## Greenlaw Building Renovation - Addendum No. 4

Date: May 30, 2019

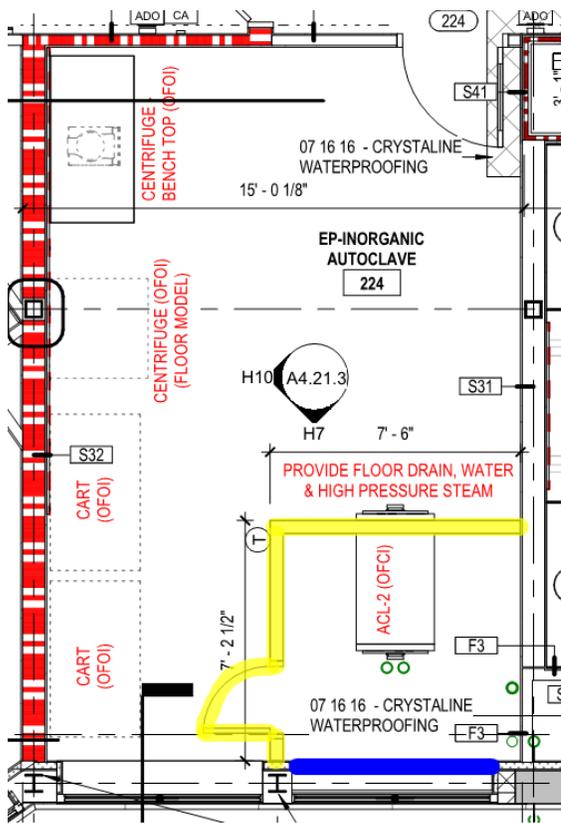
Addendum 3, item 074, our question #2 asked about type of doors are wanted at the three small rooms enclosing the owner furnished contractor installed autoclaves as these three had no door tags and were not listed among the doors on the door schedule. The answer provided indicated the doors have no tags because they are part of a special stainless-steel barrier system and Avant Garde Scientific catalog information was provided with the addendum. As further information, we note the plans for the rooms enclosing the autoclaves call for some of the partitions to be the types detailed on drawing A0.1 and they of gypsum construction. However, the ones with the doors in question, do not have a partition type callout from A0.1 so, if special stainless walls are required for these unlabeled walls, there would be a mix of gypsum and stainless in the autoclave rooms. Please indicate:

**Question #1:** Which wall(s) in each of the three rooms are to be constructed of the Avant Garde system and which are gypsum?

**Question #2:** Per the Avant Garde catalog information provided, this is an insulated system. Are Avant Gard special ceiling panels therefore also required (the reflected ceiling plans show no ceilings in rooms 224 and 402, just open to the structure above, while room 428 has ACT-4)?

**Question #3:** Is the Avant Garde system?

1. Owner furnished (as are the autoclaves)?
2. Owner installed, or contractor installed?
3. Contractor furnished, and contractor installed?

**Question #4:** Please provide a drawing showing the extent of these special partitions and ceilings so they can be quantified.

**LBA's response #1:**

- a. A metal stud/gypsum soffit is to be provided 7'-0" a.f.f. and terminate to the bottom side of floor/roof deck at yellow highlighted locations.
- b. The yellow highlighted walls below are the Avant Garde System which will terminate to the soffit.
- c. All remaining walls are as scheduled per plans.

**EP-INORGANIC Autoclave 224:**

- a. Infill blue highlight below with 2 1/2" metal studs @ 16" o.c, foam-in-place insulation, 1/2" type 1 gypsum board on each side and prime/paint.
